STORM SEWER IMPROVEMENTS

B&B Air Parts

CITY OF WICHITA, KANSAS

AS BUILTS

B&B Air Parts
SWS Plan and Profile - Line 5
Wichita, Kansas

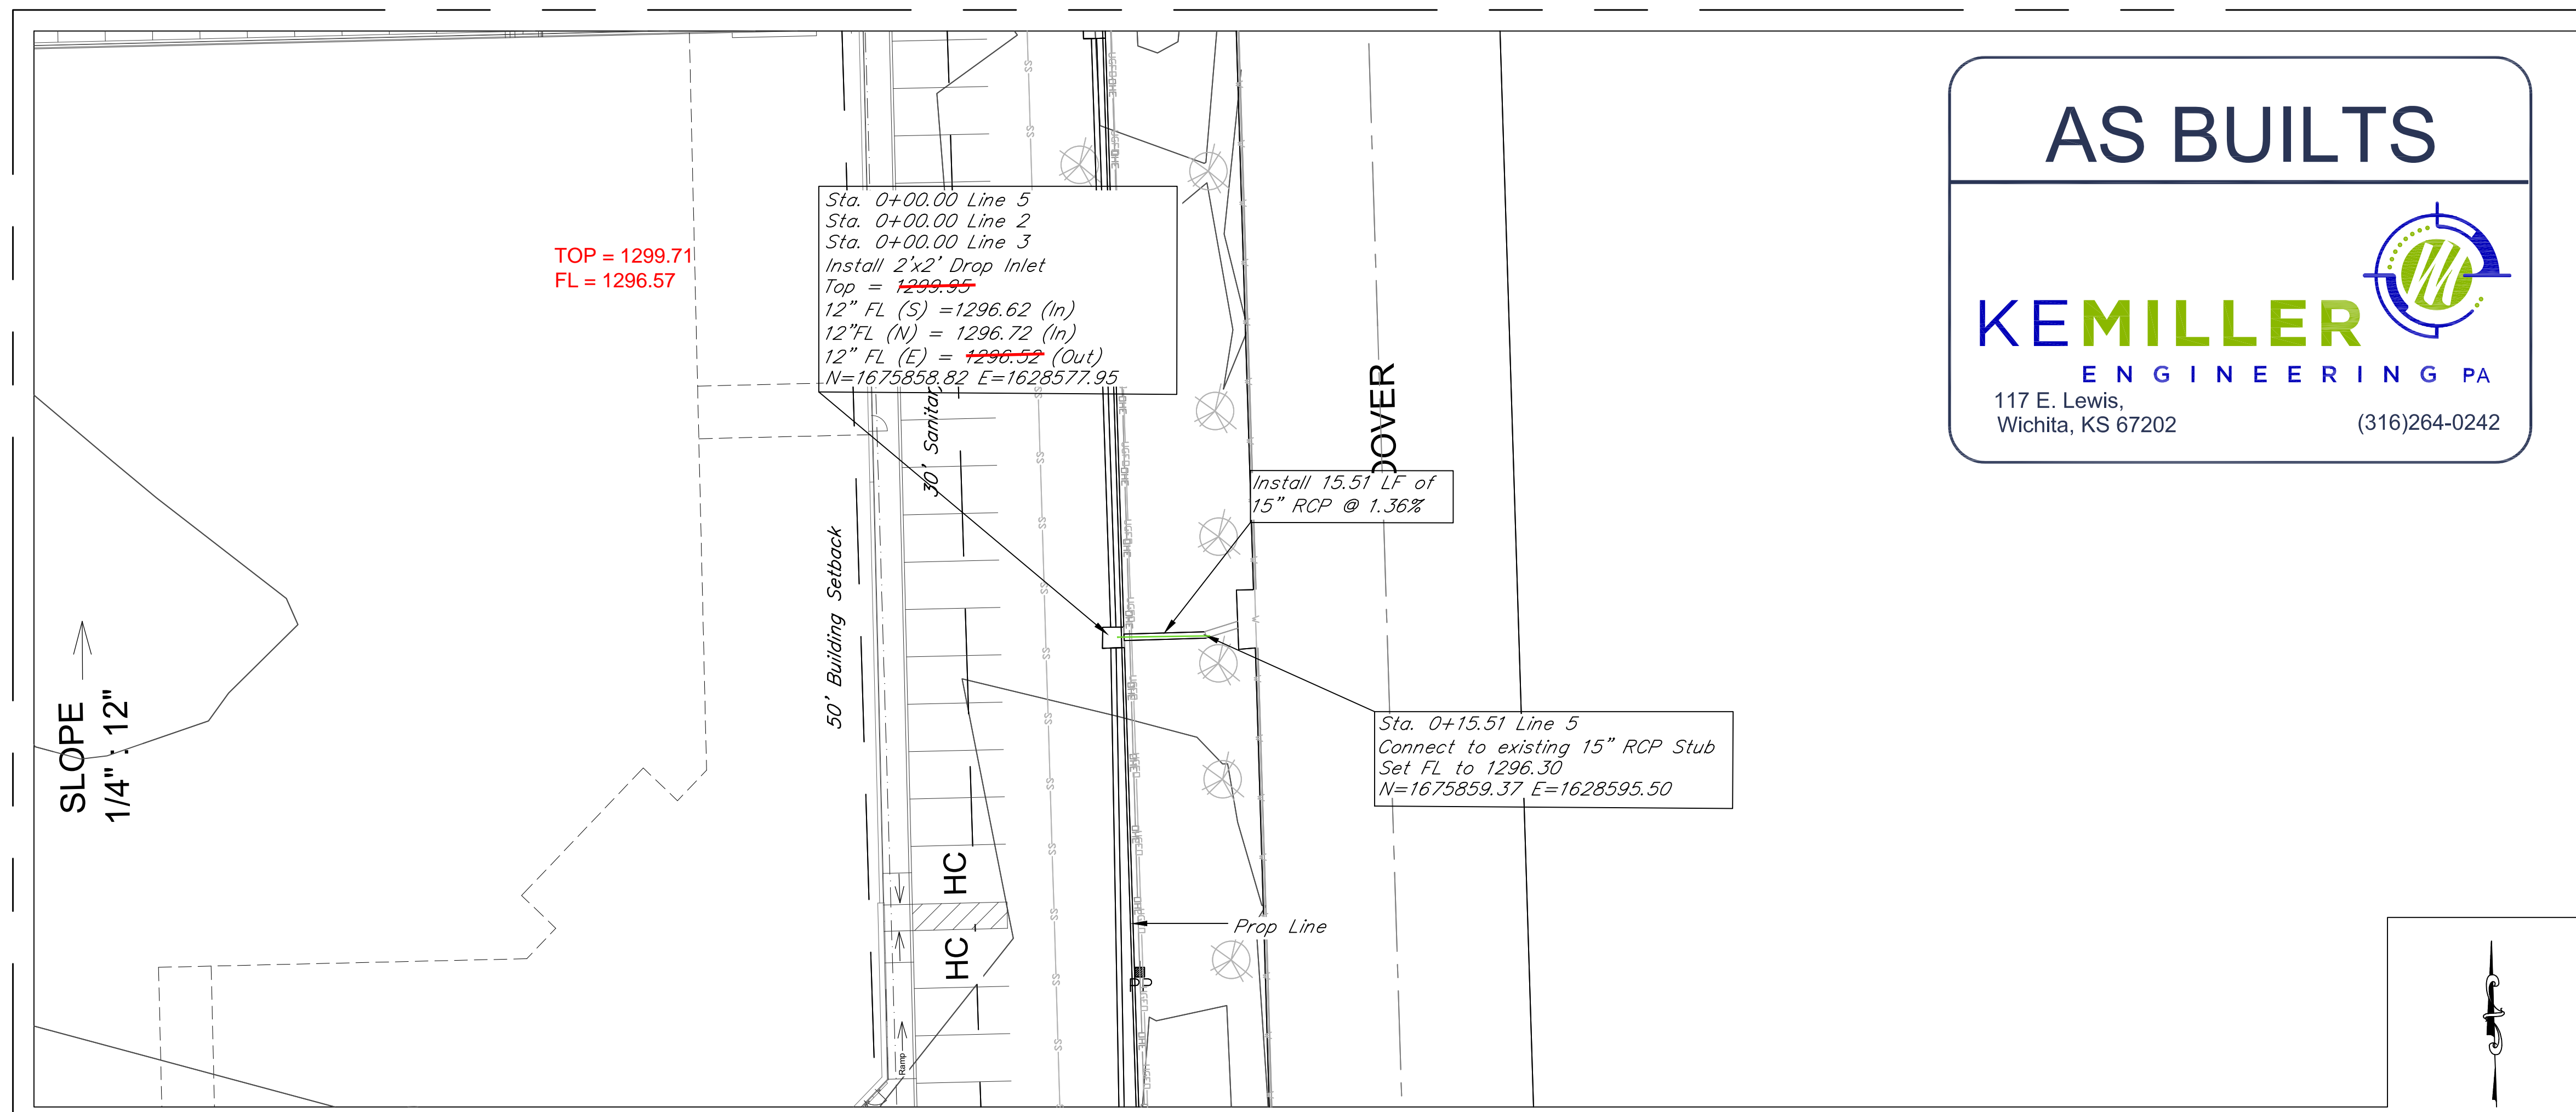
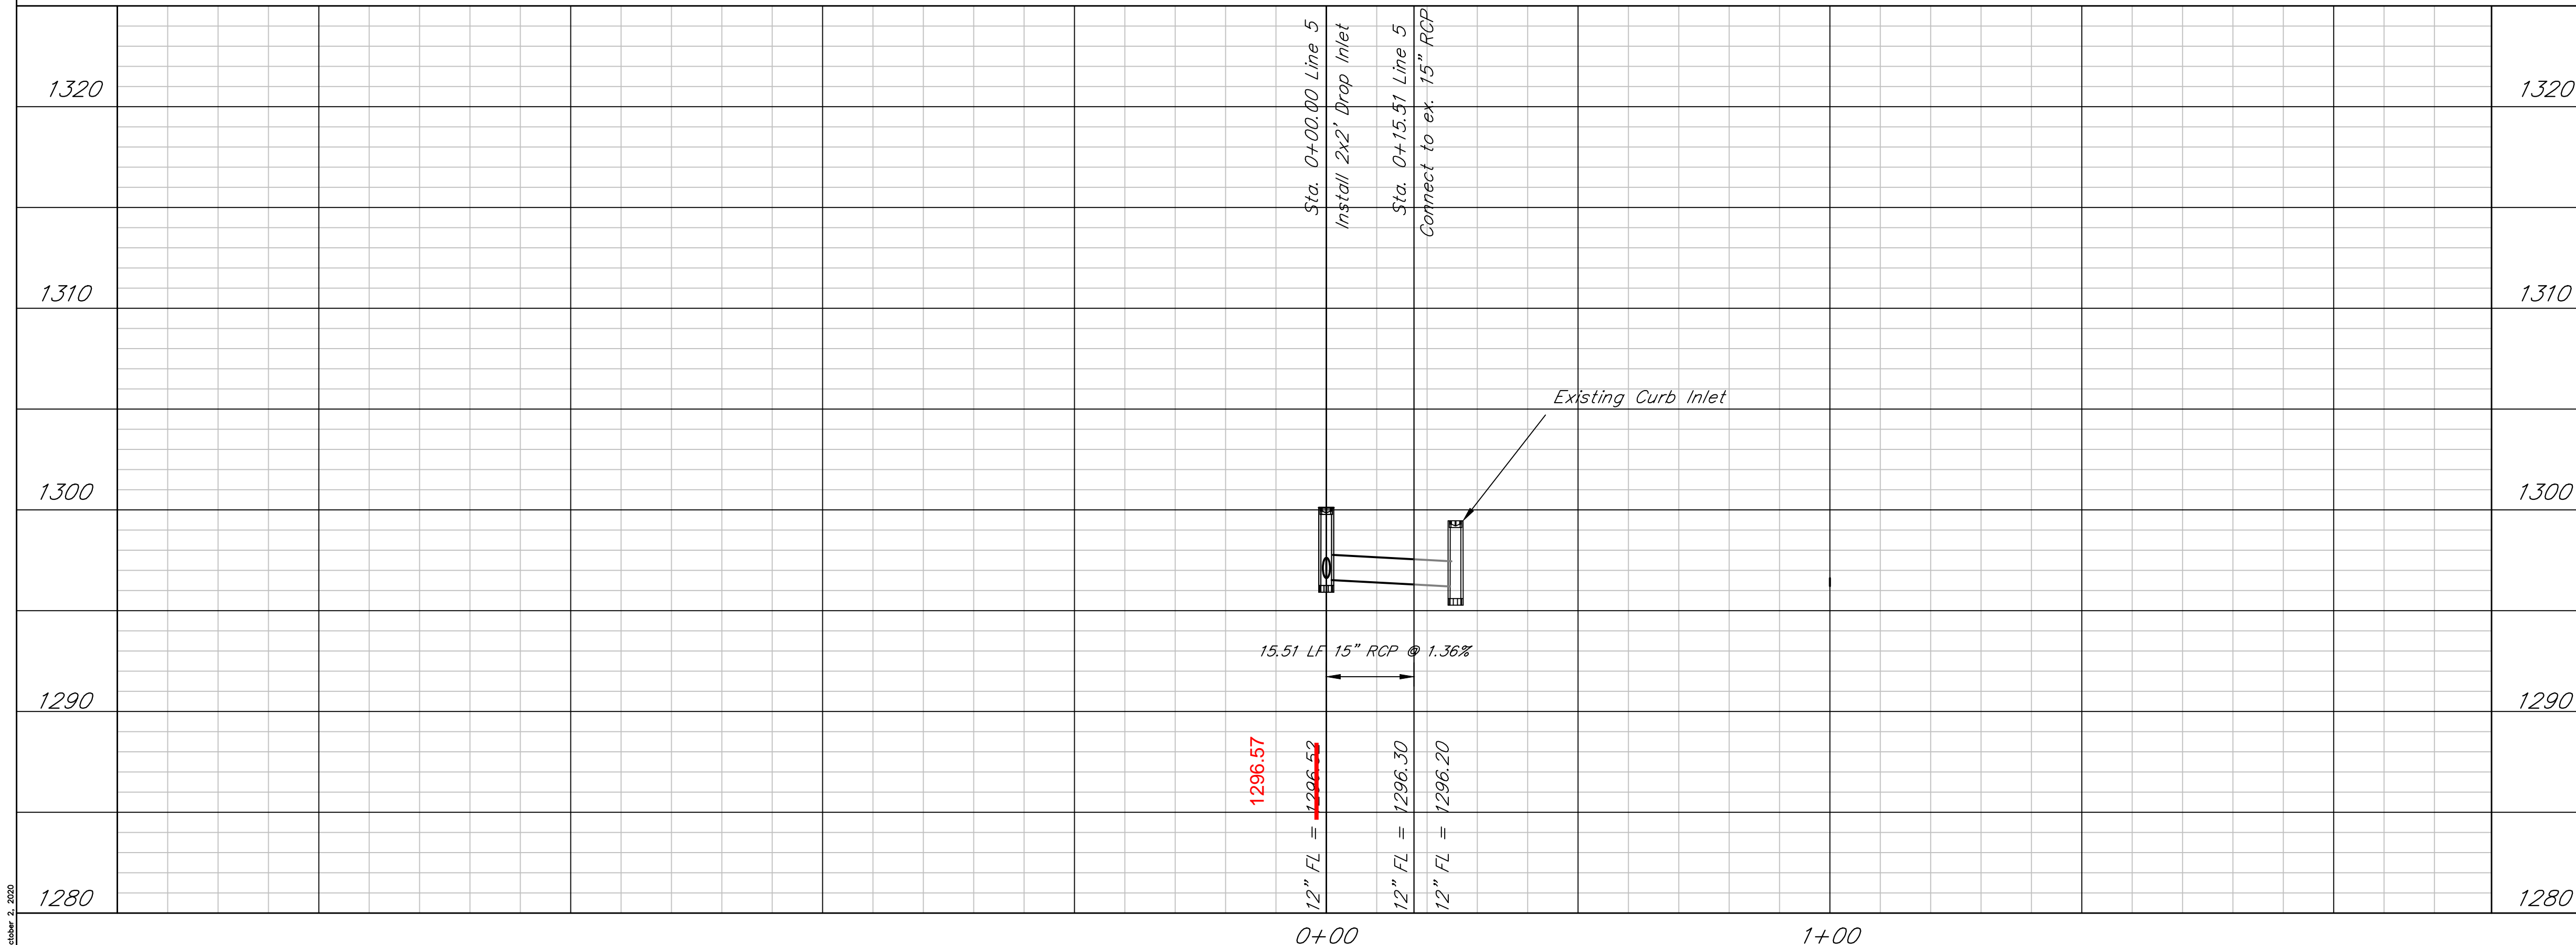
Sta. 0+00.00 Line 5
Sta. 0+00.00 Line 2
Sta. 0+00.00 Line 3
Install 2'x2' Drop Inlet
Top = ~~1299.95~~
12" FL (S) = 1296.62 (In)
12" FL (N) = 1296.72 (In)
12" FL (E) = ~~1296.52~~ (Out)
N=1675858.82 E=1628577.95
